What are differences between DTSC-200A and DTSC-200 ?

Clemens - 2025-08-25 - DTSC-200

8440-2297 DTSC-200A-352-P1 with RS485 Modbus 8440-2323 DTSC-200A-352-P2 additional Ethernet ModbusTCP	8440-1868 DTSC-200--55B

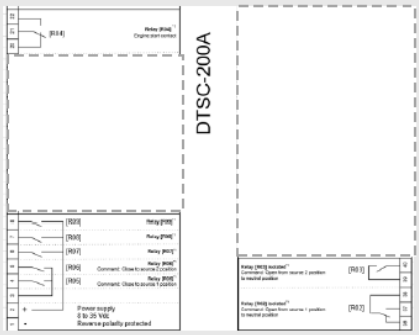
DTSC-200A	DTSC-200	Comments
Relay outputs	R01: Ready for operation relay not available. A relay can be programmed with configurable ON delay.	R01: Ready to operation tied to CPU monitoring. Programmable via LM	Overall, one less relay
Load	R02...R04 7Aac@250Vac R05, R06 2Adc@24Vdc R07...R09 3Adc@28Vdc	R01...R04 2Aac@250Vac or 2Adc@24Vdc R05...R09 10Aac@250Vac	May require additional amplifier relay
Terminal diagram

Wiring difference

Discrete inputs

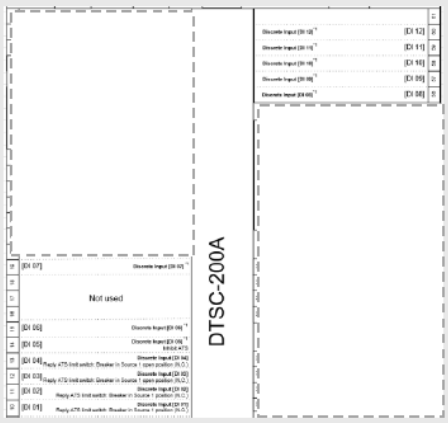
DI common connected to B-
